PROVIDENCE CITY
Land Use Authority – Staff Report
Meeting Date: February 12, 2020

Request: Applicant is requesting approval of a commercial site plan for JB Accounting Office Bldg.

RE: Site plan review – JB Accounting Building, 200 N. Gateway Drive (02-153-0024)

SITE PLAN
AS101

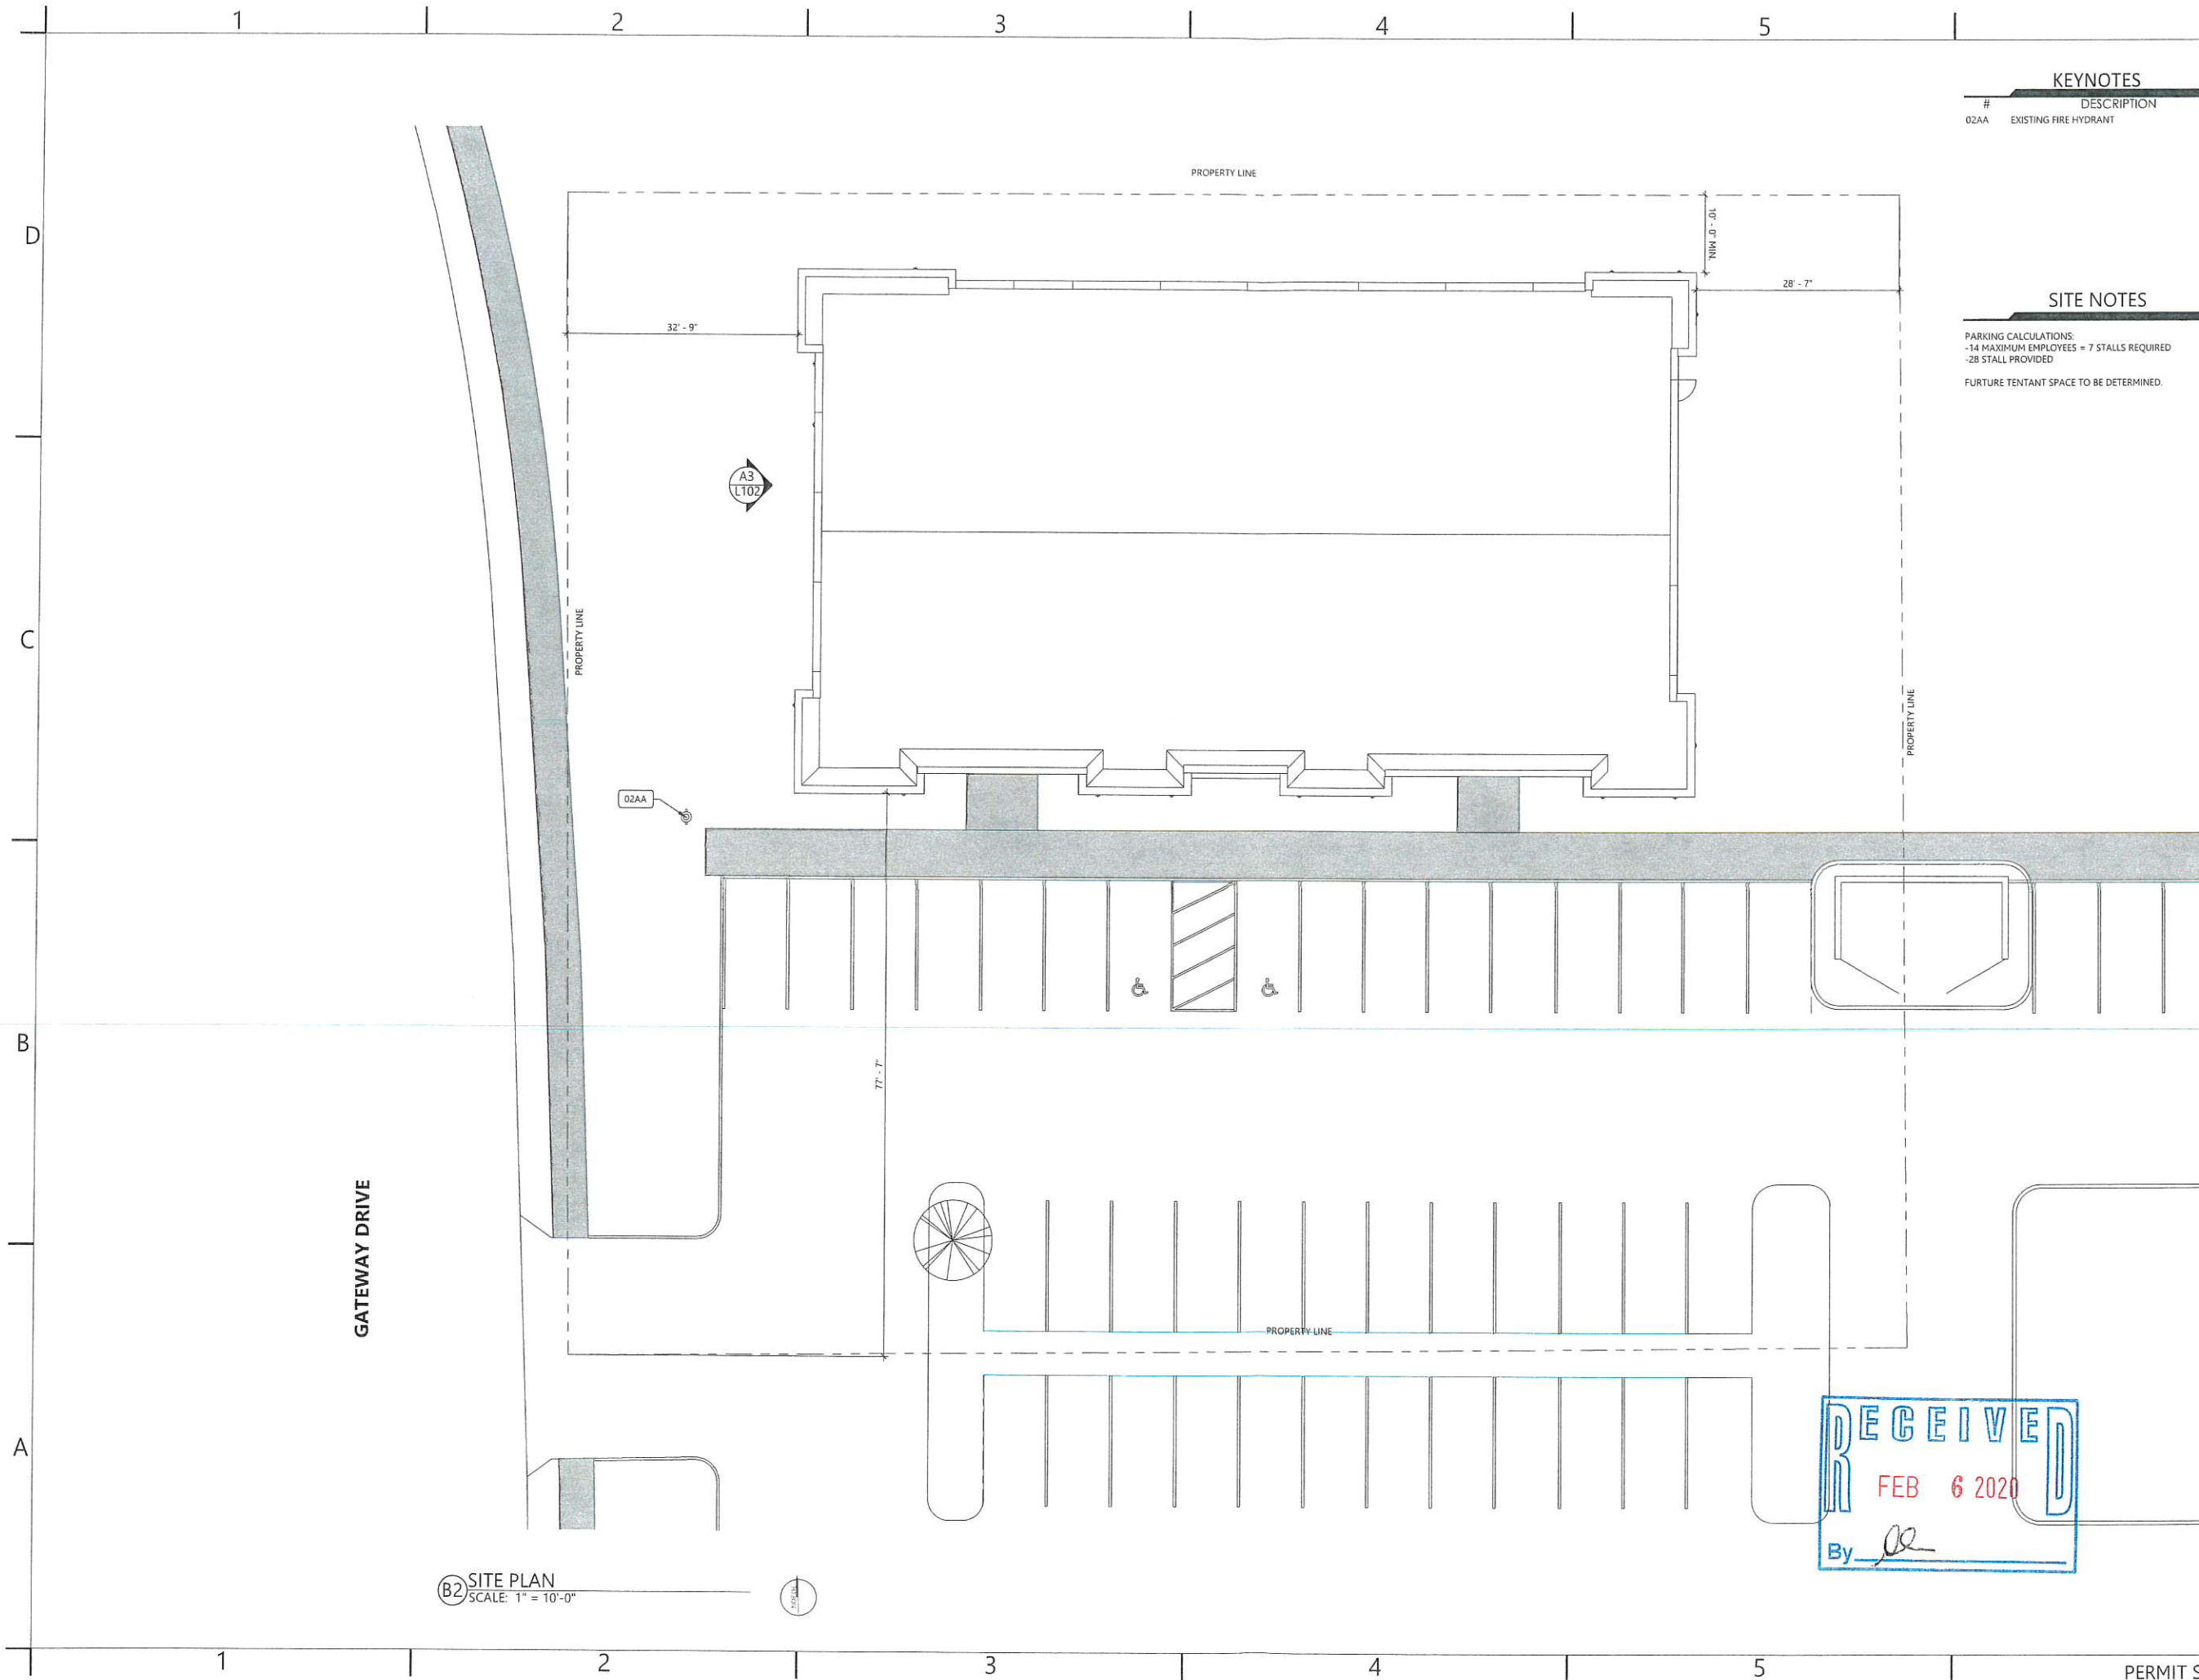
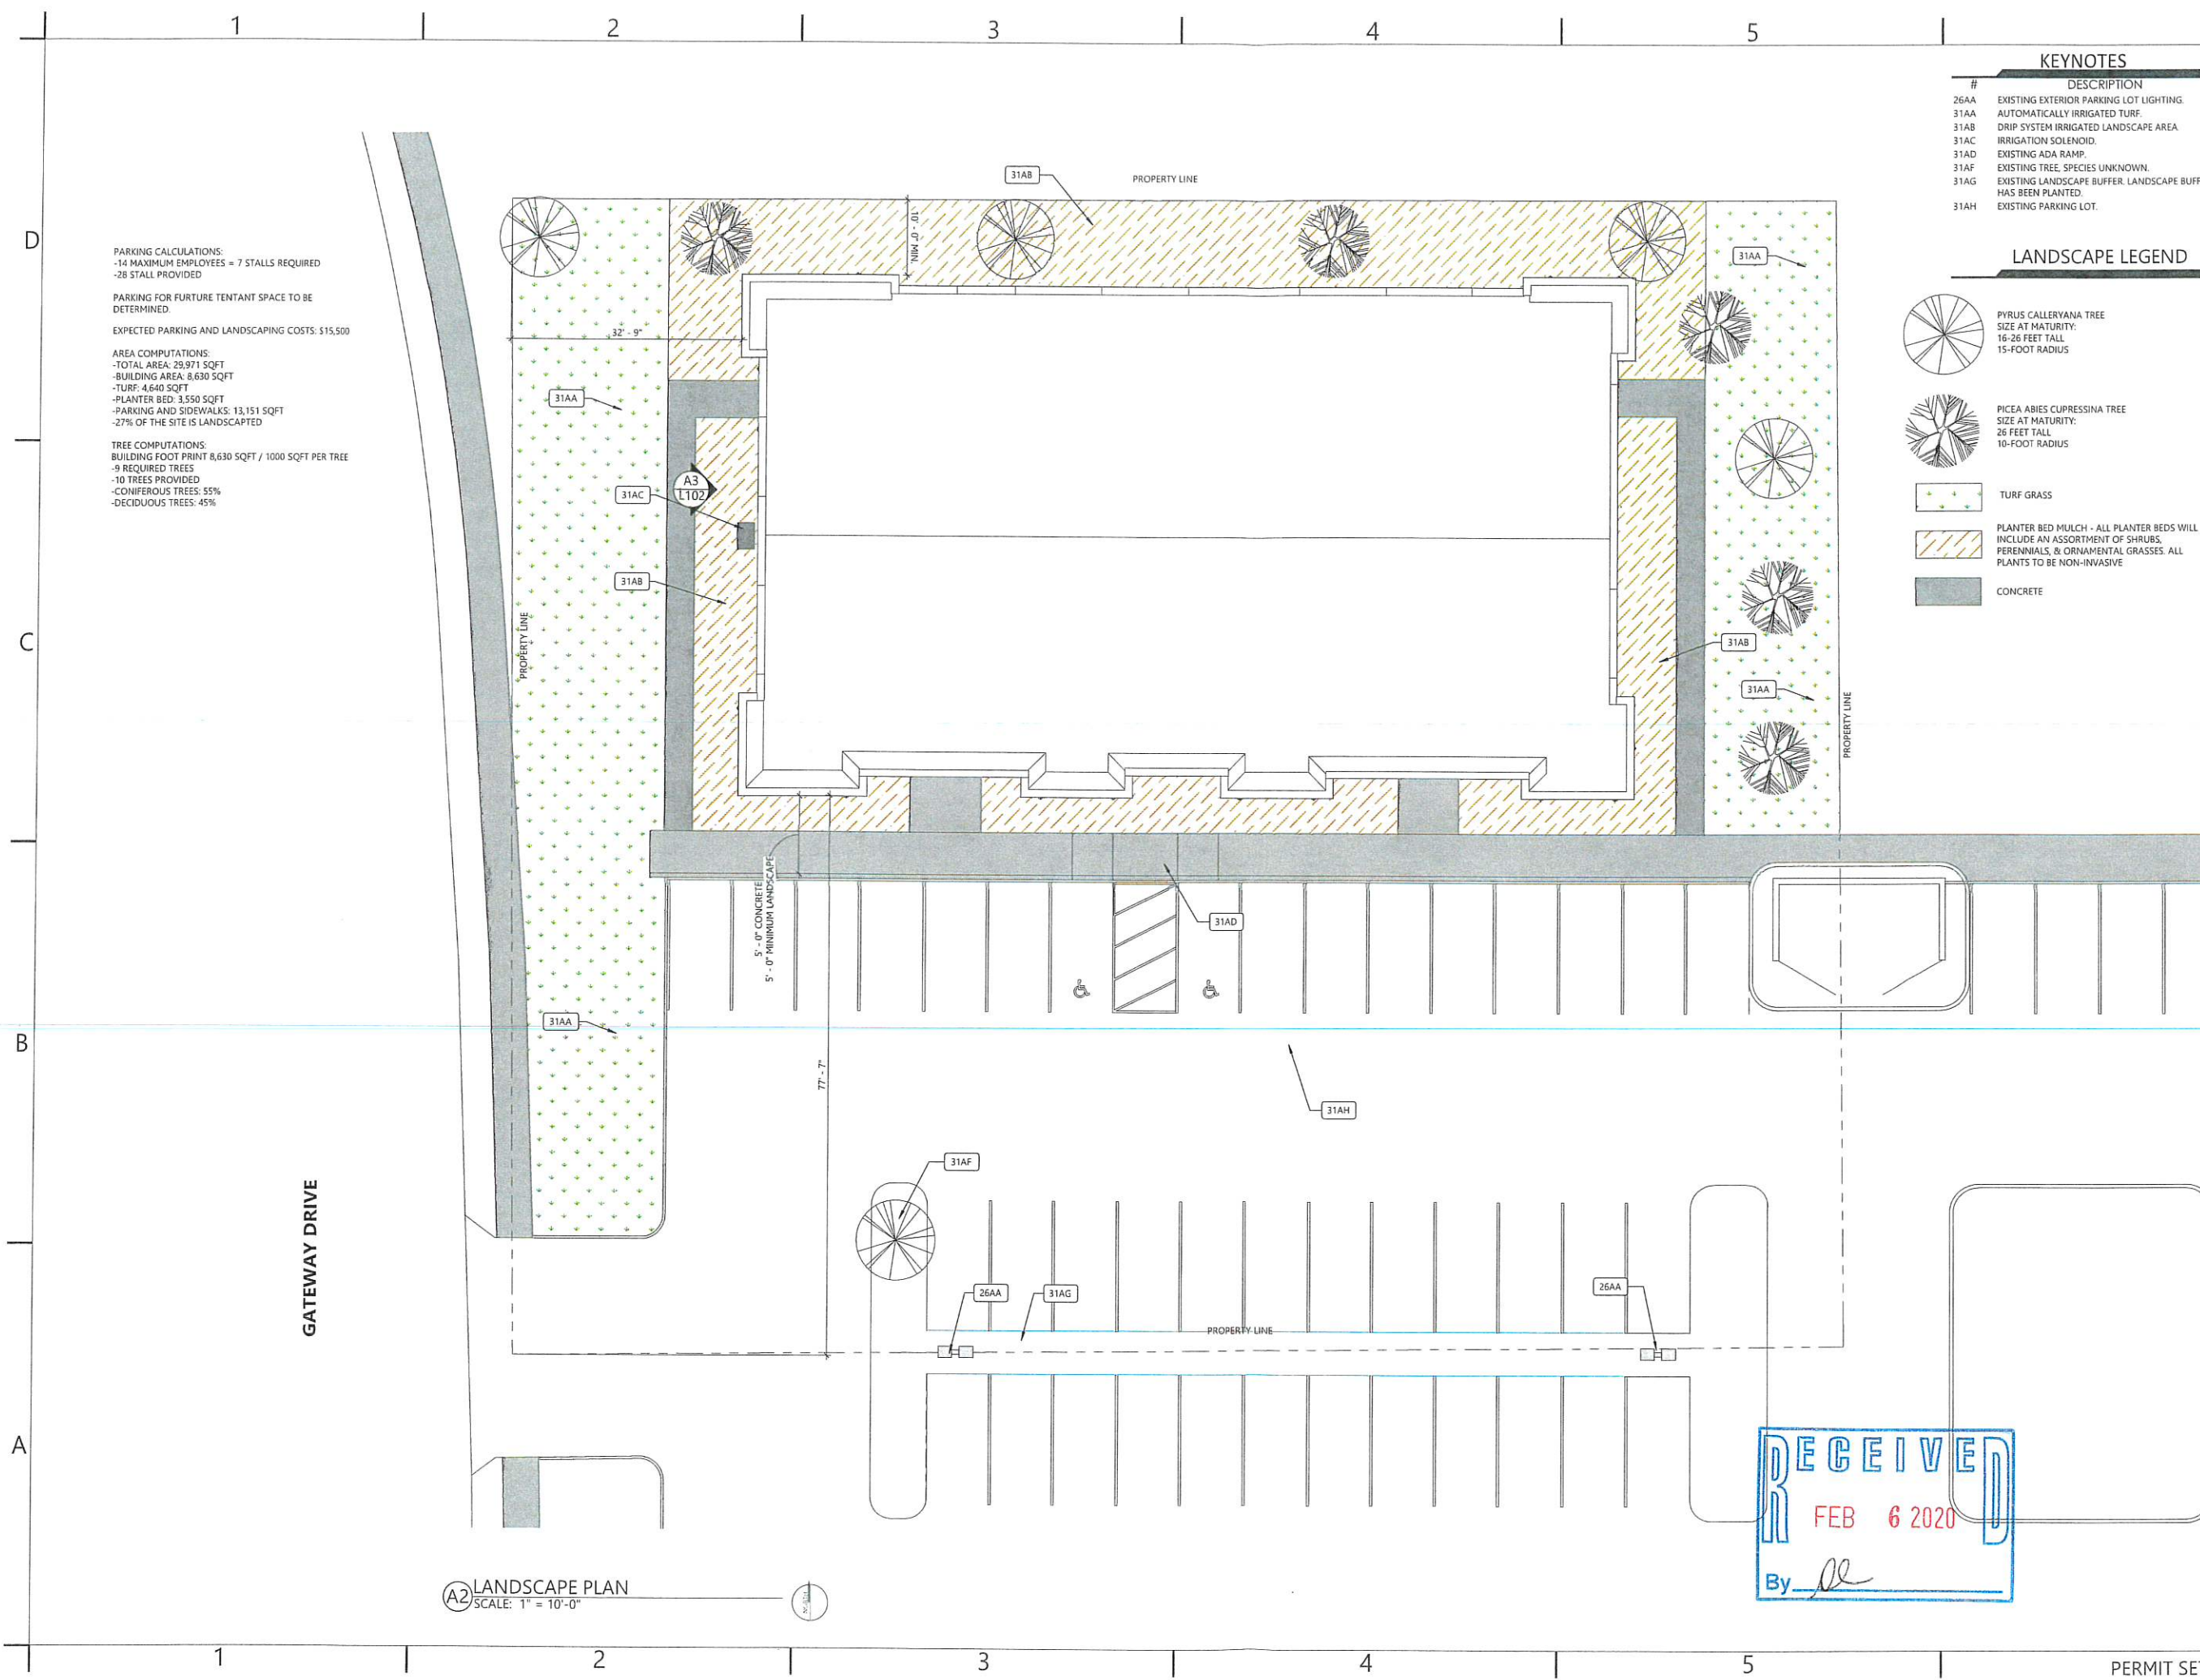
- **Fire hydrants are not Identified on submitted site plans, however, there is at least one fire hydrant within 400 feet of the farthest point of the proposed structure.**
- **If the building contains a fire sprinkler system, a fire hydrant needs to be within 100 feet of the FDC (fire department connection). The hydrant located in the parking lot could suffice if it is chosen to sprinkle the building.**

- The building appears to be approx. 8,900 sq. ft. in size. According to Table B105.1 the fire flow for a combined fire area 8,900 sq. ft. of type V-B is 2,500 GPM at 20 PSI from 3 fire hydrants. Fire Flow requirements are subject to change due to separation of fire areas, type of construction, and the installation of fire suppression system.
- **There are three Hydrants in the area of the proposed building.**
- **Fire Hydrant #342 flows 3,981 Gallons per minute at 20 PSI.**
